Amendments to the Drawings

REMARKS/ARGUMENTS

In response to the Examiner's first Office Action of November 29, 2005 the Applicant respectfully submits the accompanying Terminal Disclaimer with respect to USSN 10/760,191, Amendment to the specification, drawings and claims, and the below Remarks directed thereto.

FIG. 43

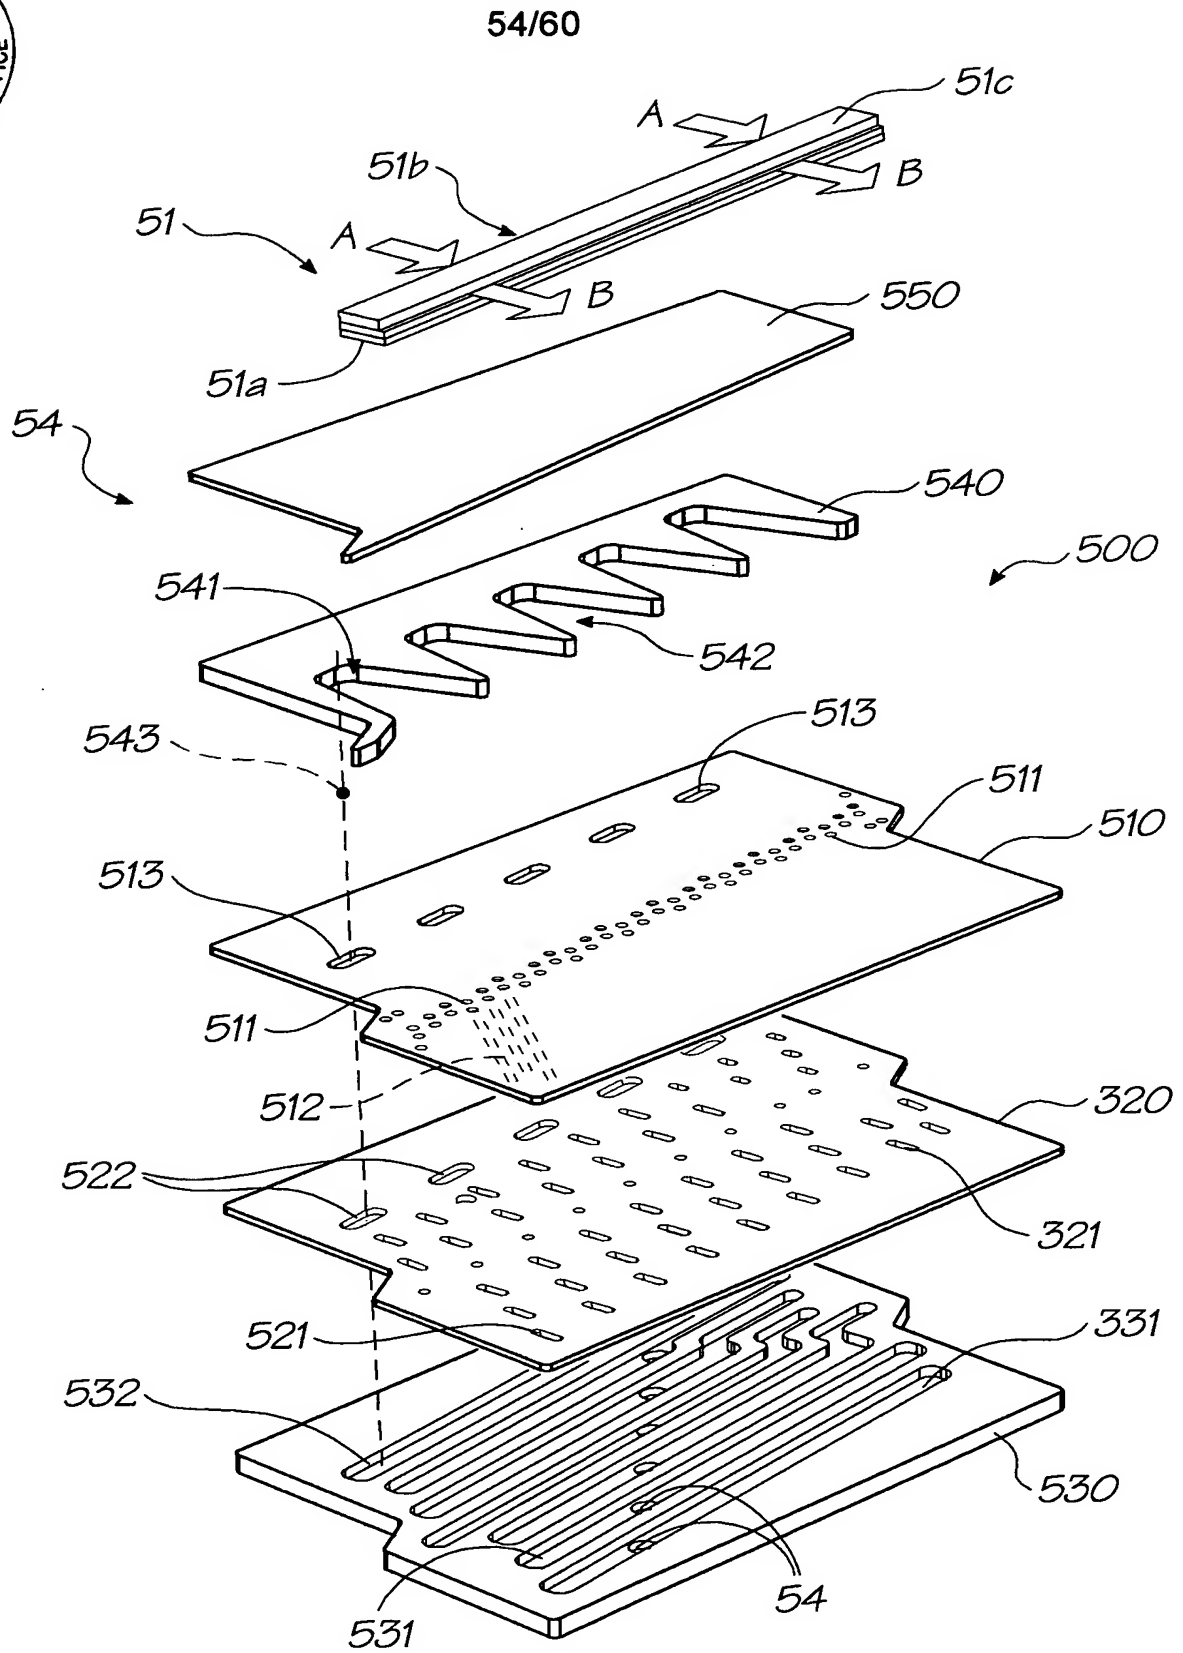
Fig. 43 is amended to include the reference sign "500", as is described at page 8, lines 19-27 of the present specification;

Regarding reference sign "500"

A corrected Fig. 43 is enclosed.

It is respectfully submitted that the above-described amendment to Fig. 43 to insert the reference sign "500", provides the correction required by the Examiner.
